Zebra QLn smart battery Pack(4336)

International Components Corporation	
Title: Zebra QLn Smart battery pack(4336)	Revision: A1.3
Project No: 4336	Draw BY: Jason
Sheet: 1 of 1	Check BY: XH/Eam
Date: Nov/09/2010	Approved By: W

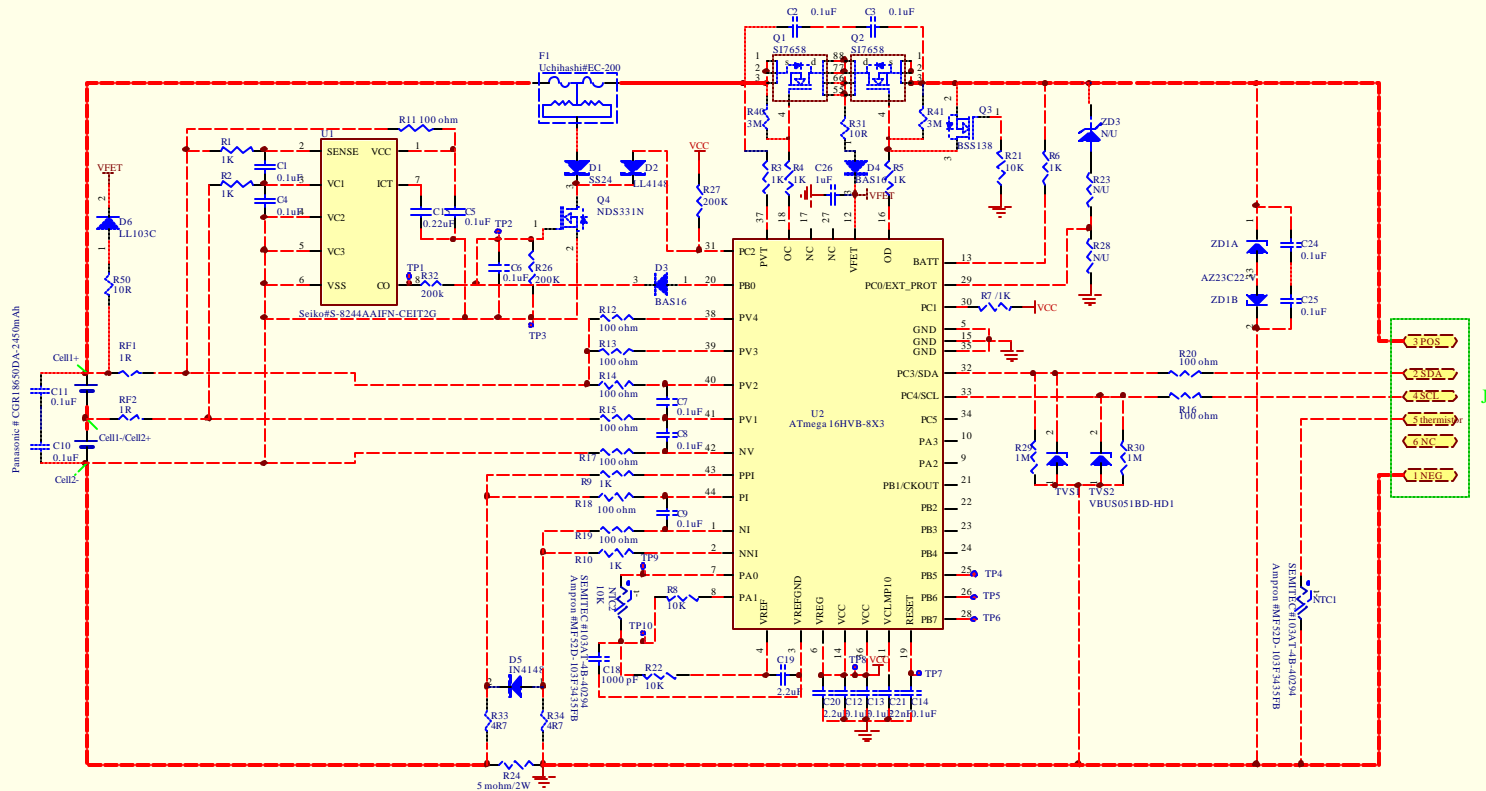
- A2: change U2 to ATMEGA32, update pinout
- A3: updated project name, and new parts R31
- A4: update project name
- A5: updated cell
- A6: add new part R40,R41
- A7: R32: change to 200K, R20 and R16 changed to 100R
- A8: U2 change from Atmega32 to Atmega16
- A9: revise Q1,Q2 drawing
- A10: add new part R33,R34,C10,C11
- A11: add new part R50,D6
- A12: NTC1 change to 103AT
- A13: R50 and R31 change from 0R to 10R
